Docket No.: 50-346 ✓

B&W Topical Report No. 10105 is presently under review in support of your application to construct and operate the Davis-Besse, Unit 1 facility. To complete the review of your application with regard to compliance with 10 CFR 50.46, certain material in addition to that submitted in the referenced topical report is needed.

Attachment 1  
 Required Information

REQUIRED INFORMATION

Figure 1  
Area of Steel Heat Sinks Inside Containment

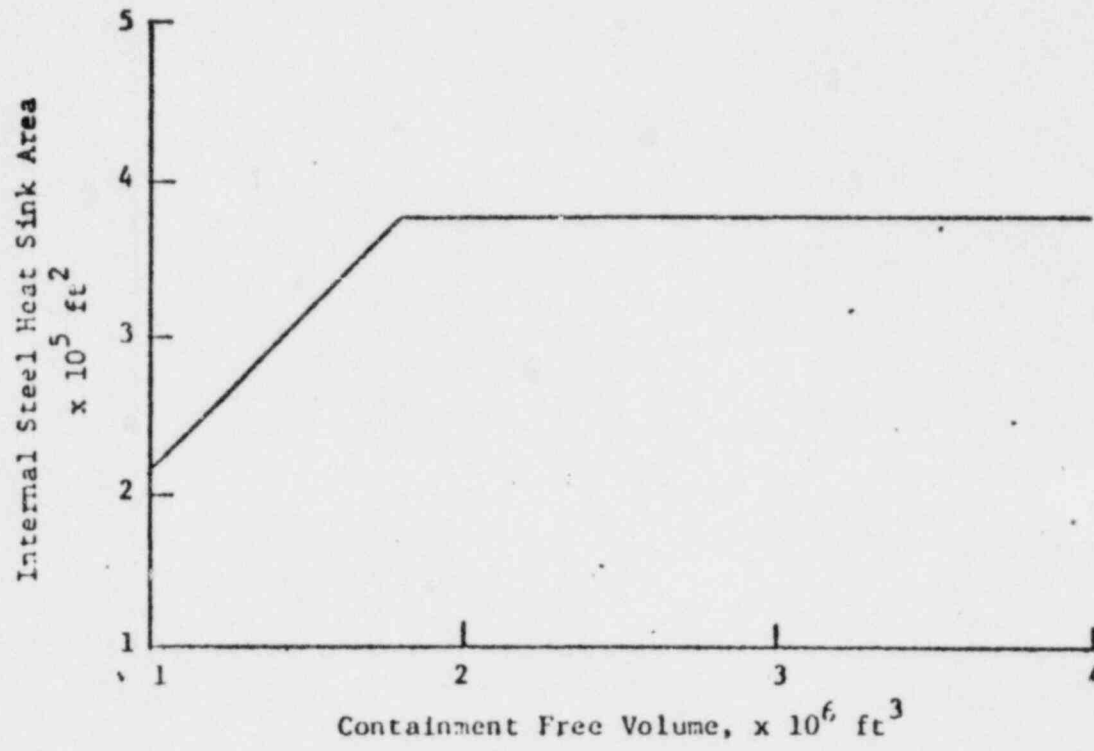
- (1) Use the surface area and thickness of the primary containment steel shell or steel liner and associated anchors and concrete, as appropriate.
- (2) Estimate the exposed surface area of other steel heat sinks in accordance with Figure 1 and assume an average thickness of 3/8 inch.
- (3) Model the internal concrete structures as a slab with a thickness of 1 foot and exposed surface of 160,000 ft<sup>2</sup>.
